SUBJECT: Department of Health Response to *Conceptual Site Model, Investigation and Remediation of Releases and Groundwater Protection and Evaluation, Red Hill Bulk Fuel Storage Facility, Joint Base Pearl Harbor-Hickam, Oahu, Hawaii*

HAWAII DEPARTMENT OF HEALTH TECHNICAL REVIEW

Conceptual Site Model, Investigation and Remediation of Releases and Groundwater Protection and Evaluation, Red Hill Bulk Fuel Storage Facility, Joint Base Pearl Harbor-Hickam, Oahu, Hawaii, dated June 30, 2019 Revision 01 (2019 CSM)

March 30, 2020

Figure 2. Bivariate diagram of the chloride concentration versus ratio of potassium to chloride.

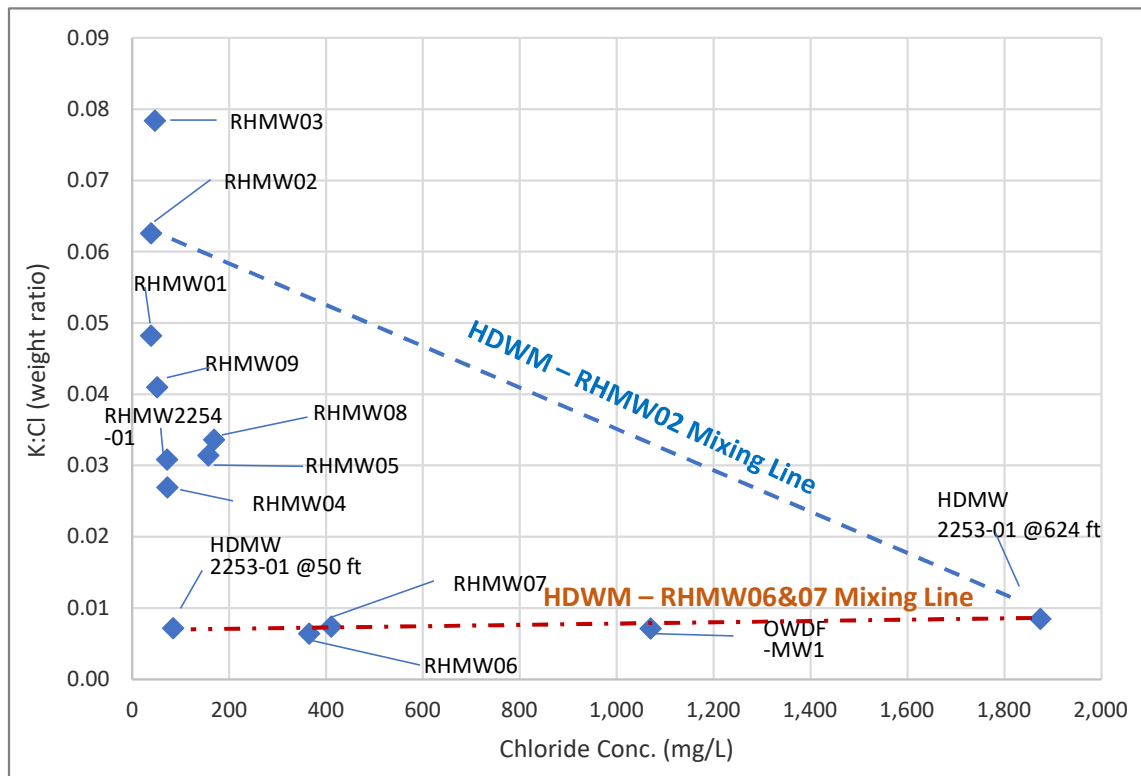
- The bivariate diagrams provided to show the mixing fail to define a coherent mixing line. If binary mixing is occurring, as the 2019 CSM suggests, there should be a linear mixing line from one end-member (Halawa Deep monitoring well at a depth of -624 ft msl) to the other end-member (RHMW02 or RHMW03) with RHMW04, RHMW06, RHMW07, and RHMW2254-01 falling on that line as intermediate mixtures of the two water types. Figure 2 adapted from Figure 6-38 of the 2019 CSM shows that a mixing line from HDMW2253-03 (-624 ft) to the RHMW02 or RHMW03 end members does not pass through the intermediate wells located between the presumed source water and the end-member wells. Figure 3, below, from Hunt (2014) is an example of bivariate mixing where most wells fall close to the mixing line from “MW401 deep” to the

Honokohau Well. The wells that fall off this line (e.g. KAHO 2 and KAHO 3), show chemical enrichment from sources other than the two end members. What the bivariate diagrams presented in the 2019 CSM shows is a more complex mixing system where there is potentially sluggish groundwater movement.

Figure 4. The TPH-d trends at RHMW01 prior to and after the 2014 release.

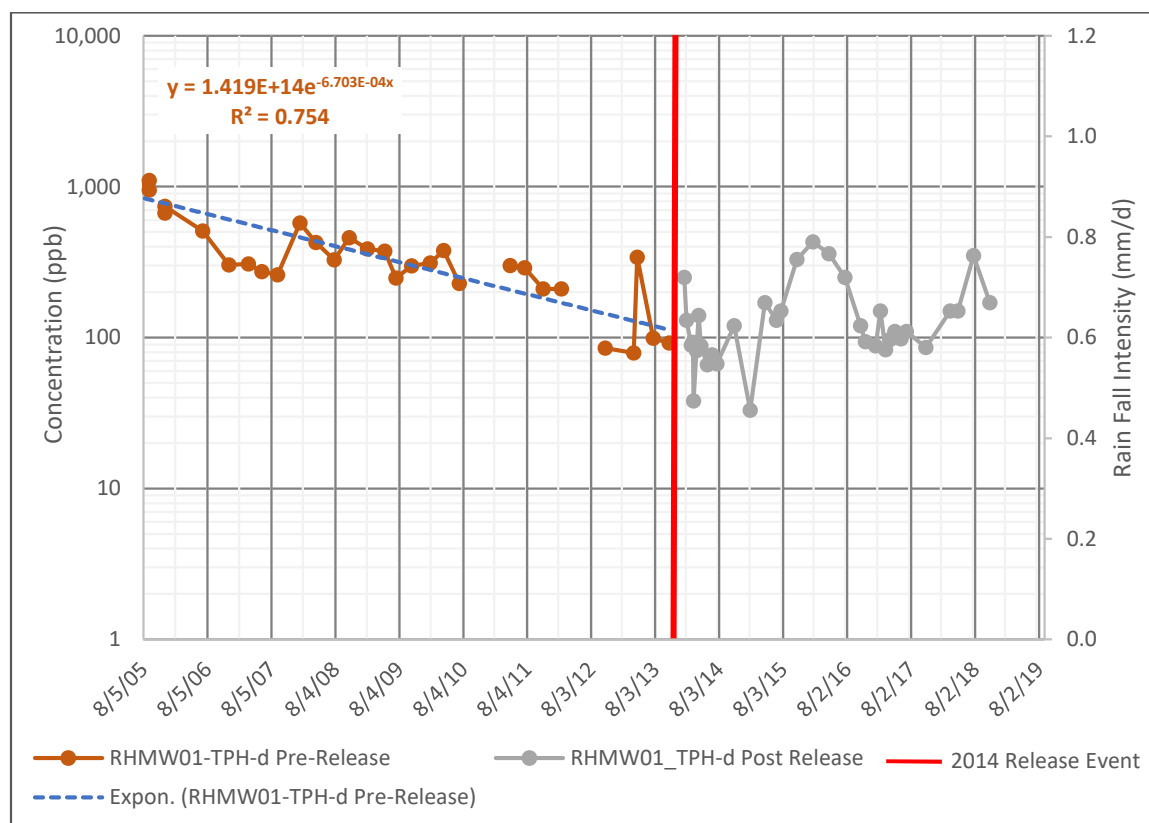
- d. Inspection of RHMW01 TPH-d trends strongly suggest that the contaminant chemistry at this well is impacted by the 2014 release. Figure 4 shows the TPH-d history for RHMW01. Prior to the 2014 release there is a well-defined decreasing trend in TPH-d as indicated by a high correlation coefficient of 0.75. From 2014 onward this decreasing trend ceases being replaced by systematically increasing, then decreasing

TPH-d concentrations that have the appearance of a breakthrough curve. The logical conclusion is that the 2014 release did indeed appear in RHMW01 as a TPH-d break through curve.

Figure 5. Naphthalene concentrations at RHMW02 and the influence of intense rainfall on the naphthalene concentrations prior to the 2014 release.

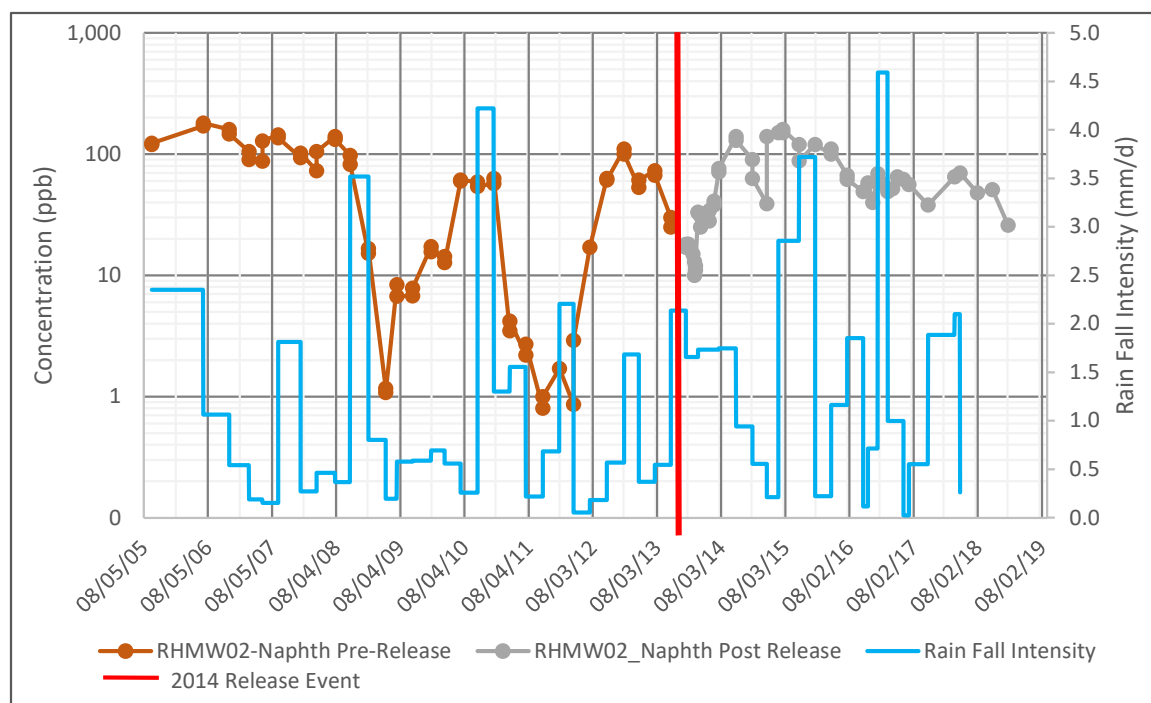
various analyzing laboratories during the history of the Red Hill monitoring. This conclusion does not consider other likely sources of variability. Figure 5 shows that the naphthalene concentrations at RHMW02 significantly decreased following periods of intense rainfall in 2008 and 2010. This correlation was also found to be true for TPH-d.
